## **DESIGN REVIEW COMMITTEE**

STAFF REPORT AND FINDINGS OF FACT
-----------------------------------

SUBJECT: DESIGN REVIEW REQUEST (DR19-03) BY MMCG GOI ASTORIA LLC TO  
CONSTRUCT A COMMERCIAL RETAIL FACILITY AT 2190 MARINE DRIVE

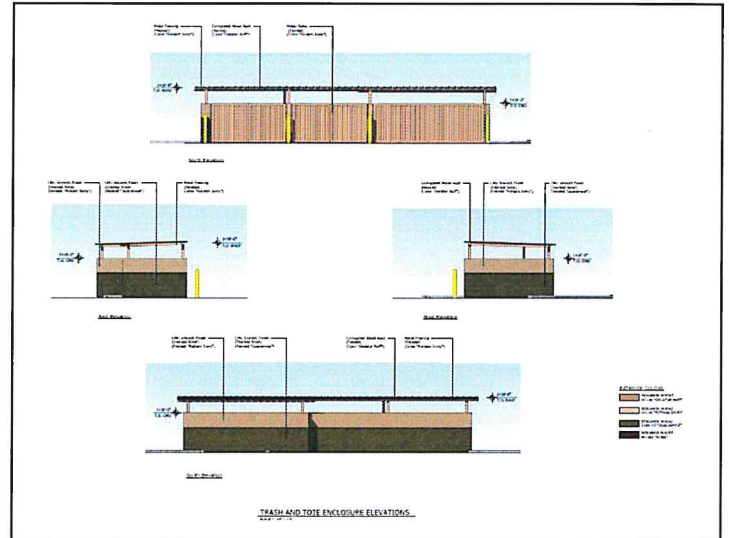
for the solid waste disposal storage enclosure to comply with the requirements of Section 3.215 and 14.030.G.3.b and shall work with the solid waste disposal company to verify size and location of the facility. The plans shall be reviewed and approved by the Planner prior to issuance of the building permit (Condition 10).

10. The applicant shall submit a revised design for the solid waste disposal storage enclosure to comply with the requirements of Section 3.215 and 14.030.G.3.b and shall work with the solid waste disposal company to verify size and location of the facility. The enclosure shall be sided to match the main structure. The plans shall be reviewed and approved by the Planner prior to issuance of the building permit.

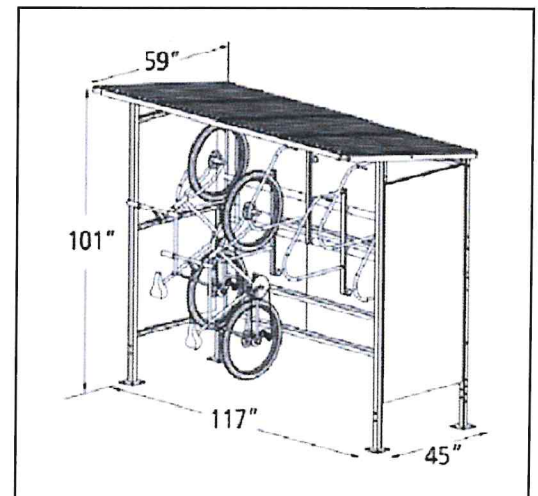
The bicycle storage area is proposed to be a three-sided enclosure for 4 to 6 bicycles; option of polycarbonate wall panels either galvanized or powder coated; option of either polycarbonate or galvanized S deck roof. The exact design of the storage area to meet the requirements of Development Code Section 7.105 will be reviewed by the Planner and is not part of the Design Review Commission review. However, the location and materials are part of the DRC review.

Polycarbonate is a thermoplastic polymer and is not one of the “encouraged” wall treatments. The option for a galvanized or powder coated metal would be similar to the vertical corrugated metal siding on the main building. The bicycle storage area shall have siding to match the main structure to be reviewed and approved by the Planner (Condition 14).

13. The applicant shall obtain all necessary City, State, building permits, or other permits as needed.
14. The bicycle storage area shall have siding to match the main structure to be reviewed and approved by the Planner.

**Figure 4: Vision Clearance Area for Non-Residential Driveways**

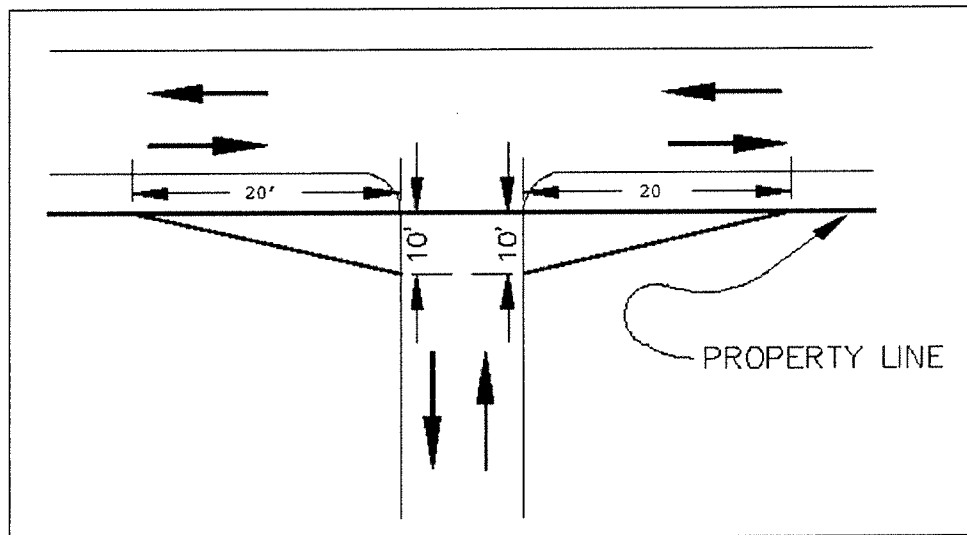
Parking areas are required to be separated from pedestrian areas with landscaping. The site plan indicates landscaping between the parking area and the pedestrian sidewalk in the right-of-way. As noted in Sections 14.030.A.1 and 14.030.C above, the parking area should be located behind the building and not adjacent to pedestrian areas. Due to the lot configuration, the parking lot is proposed to be located at the focal point of the site adjacent to the Commercial Street and Marine Drive pedestrian walkways. However, to mitigate this location, landscaping should be installed to be sufficient to buffer the view of the parking area from the adjacent rights-of-way (Condition 5). However, the landscaping shall also comply with the Vision Clearance Area as required by City Code.
